**NEEDHAM
ZONING BOARD OF APPEALS
AGENDA**

Minutes	Review and approve Minutes from March 16, 2023 meeting.
Case #1 – 7:30PM	1000 Olin Lane – ENGIE Distributed Renewables Development, LLC has applied for an Amendment to a Special Permit under Sections 5.1.3 and any other applicable Sections of the By-Law to waive parking plan and parking design requirements to permit the installation of a 480kW AC solar canopy array over the existing Main Parking Lot A at Olin College. The property is located at 1000 Olin Lane, Needham, MA in the Institutional District.
Discussion	2023 ZBA Meeting Schedule

Developer proposes constructing a 480kW AC solar carport canopy over existing Main Lot A.

OLIN WAY SOLAR

FILE PATH: \\PCH\FIELD2\B00\TEST\LOCAL\CH1\COMPANY DATA\NEW FOLDER STRUCTURE\PROJECTS\OLIN WAY_MA_OLIN\ENGINEERING AND DESIGN\DRAWINGS\C3.00 - GRADING & STORMWATER MANAGEMENT PLANDWG 3/30/2023 BY: W5893

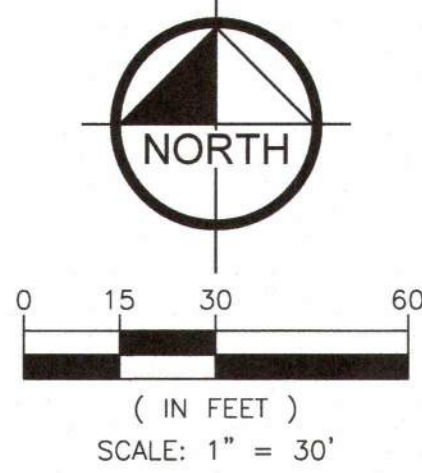
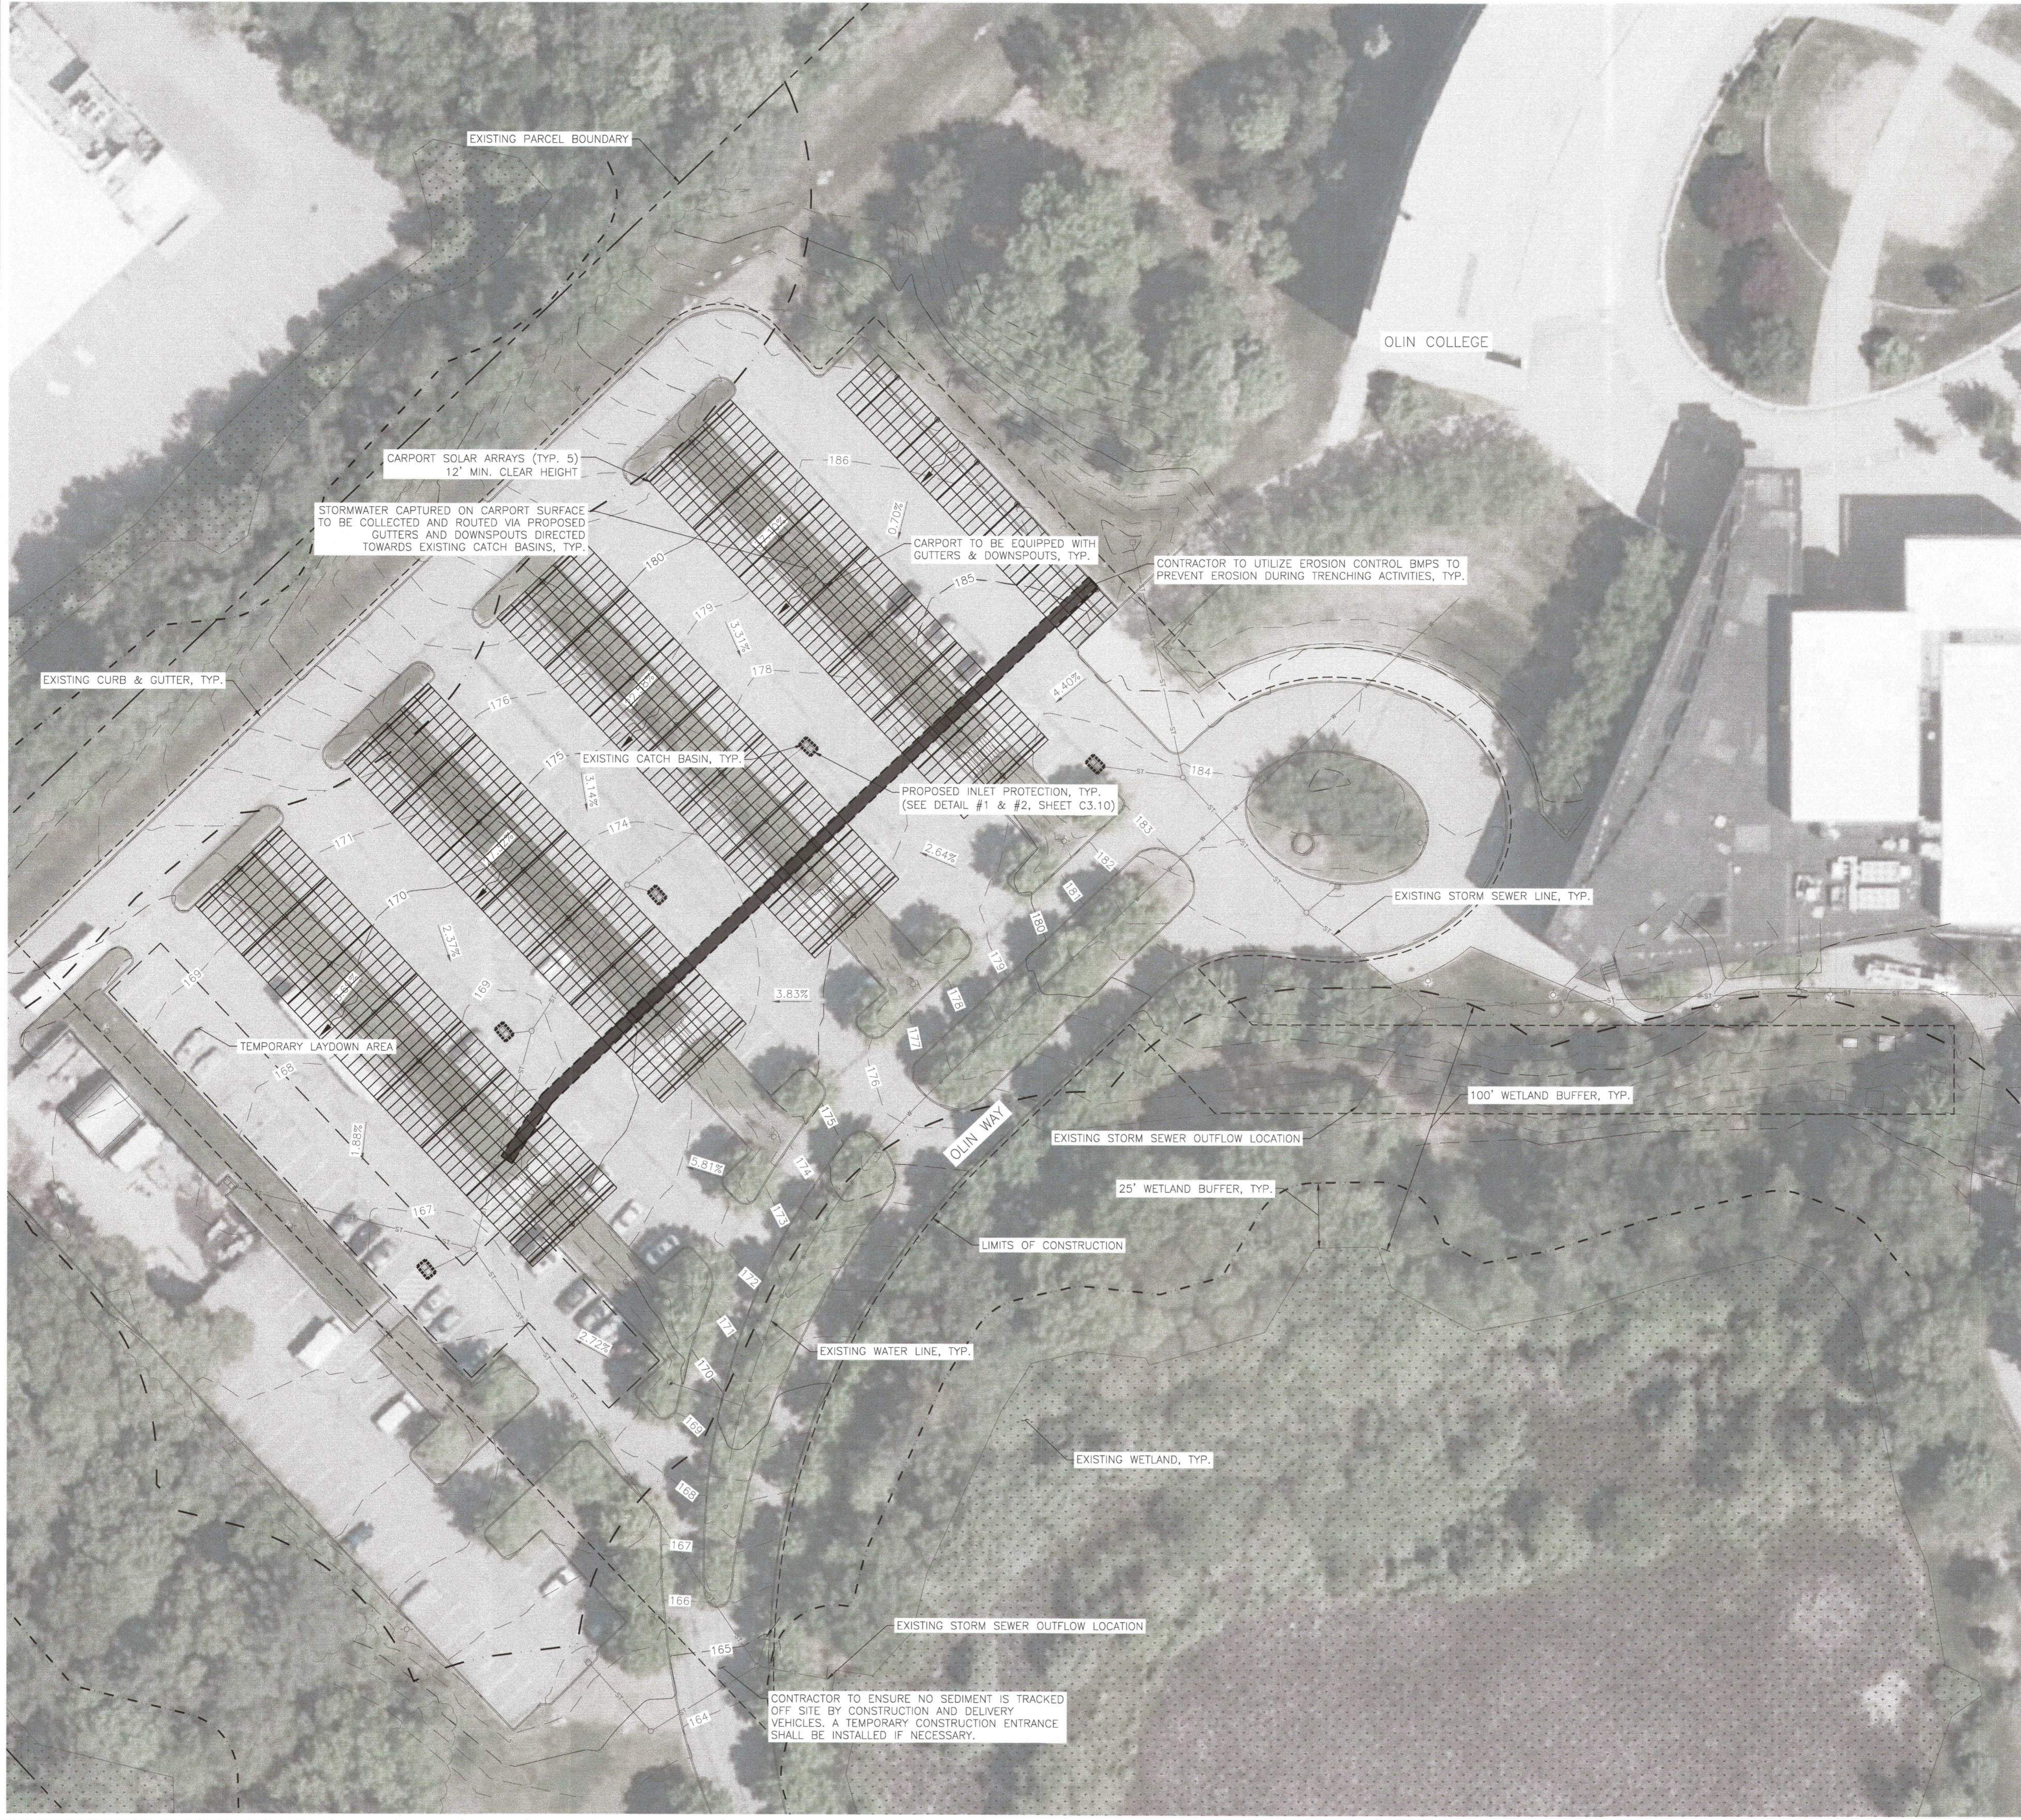
- In accordance with the Town of Needham Stormwater Bylaw, the proposed new structure requires a minimum combined volumetric capacity of 1 inch over the entire impervious area of the addition to be recharged. The plans should be revised, prior to receiving a building permit, showing the calculations that the infiltration system is sized to contain a minimum of 1-inch of the total impervious area of the addition for infiltration.
